STAFF REPORT

RE: Case No. CD-CPC-2018-00153

REQUEST: A request to approve a development plan for a 14-story, 132 unit residential building with 2,135 square feet of retail space on a property zoned DX-15 (Downtown Mixed Use).

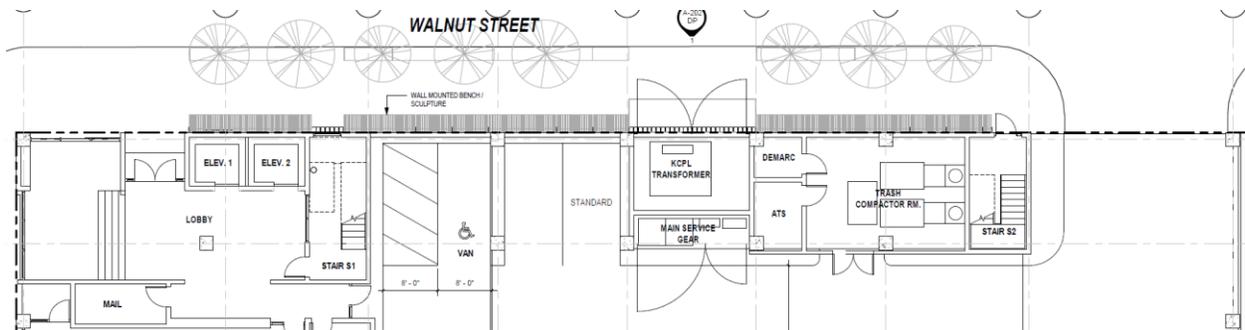
about ¾ of the façade along Walnut consisting of garage. Staff and the applicant have been in discussions regarding this significant issue. As a means of creating a more interesting pedestrian experience without altering the building's interior to make way for greater storefront along Walnut, the developer is interested in pursuing an alternative within the right-of-way adjacent to their building. The alternative would include standard improvements (replacing sidewalk and installing street trees) as well as working with Public Works Department to utilize some of the on-street parking spaces along Walnut in front of the building as a dedicated food truck space and widening the sidewalk further to add some seating and other amenities. The applicant has provided a sketch reflecting this idea below.

Staff is more than willing to consider alternative methods of activating our pedestrian spaces beyond the standard request to add ground-level commercial space. This is an interesting option to consider; however it has not been done before and will require coordination of and approval from Public Works Department. Staff understands the development team has an aggressive timeline, so they will need to pursue this idea as aggressively and concurrent with the remainder of the project with Public Works in coordination with City Planning and Development.

- b. The applicant agrees to work with City Planning & Development staff, as well as Public Works in order to facilitate active pedestrian experience within the Right Of Way along Walnut Street, or the plans are revised to show additional ground-level commercial space along Walnut St.

Figure 3. Initial Proposal to Activate Streetscape provided by applicant. It proposes two parking spaces for uber and food truck as well as some table and chair arrangement under street trees for seating (presumably for food truck customers).

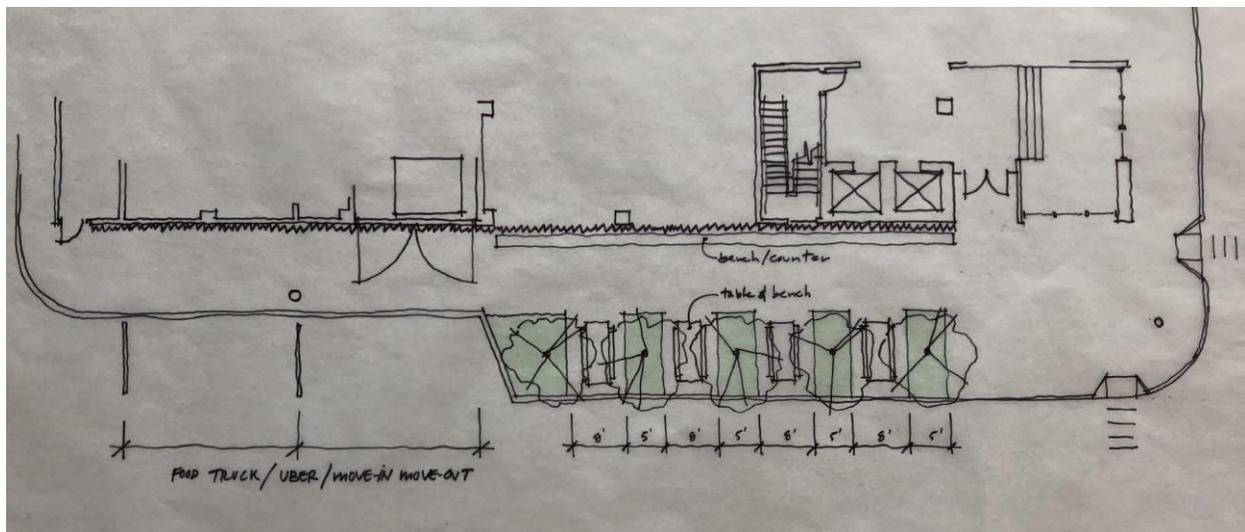
If City Plan Commission is supportive of going this route to achieve the goal of activating the street space, staff will assist in coordinating this for the applicant. Staff supports the idea of utilizing at least one of the two spaces as a permanent or semi-permanent space dedicated to food trucks (preferably multiple ones on a rotating basis).

3. That the developer obtains approval of a project plan from the City Plan Commission which details the proposed use of the right-of-way in service of the achieving the goal of activating the street. Submittal and approval of the plan, as well as construction of improvements proposed therein, is required prior to Certificate of Occupancy.
